MAINE TURNPIKE AUTHORITY

ADDENDUM NO. 1

CONTRACT 2025.12

SLOPE AND DRAINAGE REPAIRS
MM 0.0 TO MM 109.1

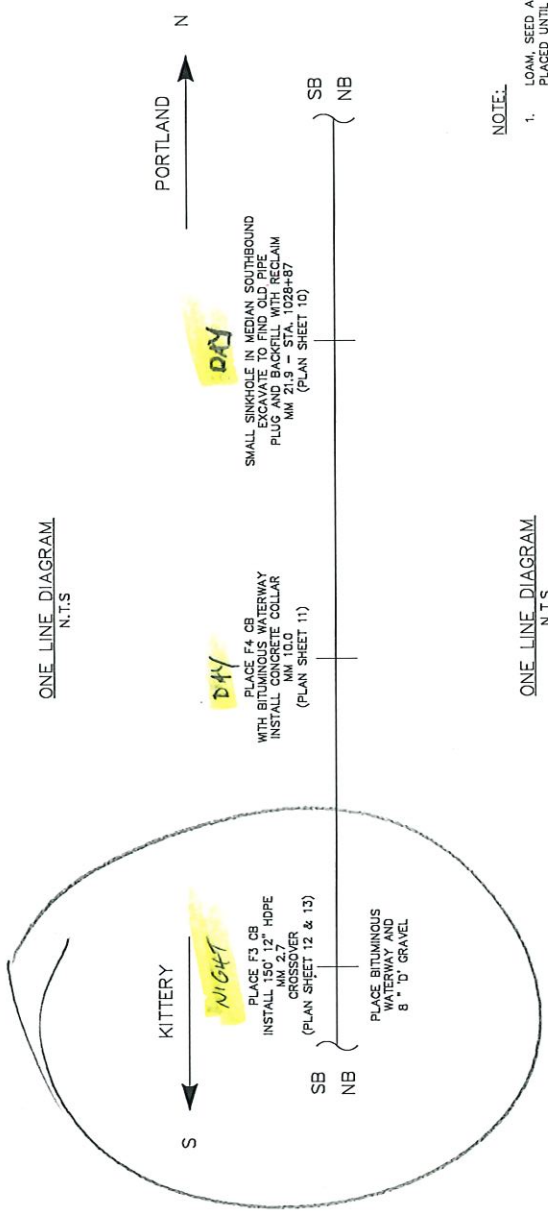
NOT TABLES hours
6' LED
Short haul water to MAINT. YARD - OK
S of Portland may be a window

5/15/25 → ? Note C.
→ Add #1 5/16/25

1. LOAM, SEED AND EROSION CONTROL BLANKET CAN NOT BE PLACED UNTIL BITUMINOUS CURB IS PLACED UNDER GUARDRAIL WHICH IS IN CONTRACT 2025.14 AND TO BE INSTALLED BY AUGUST 15, 2025.
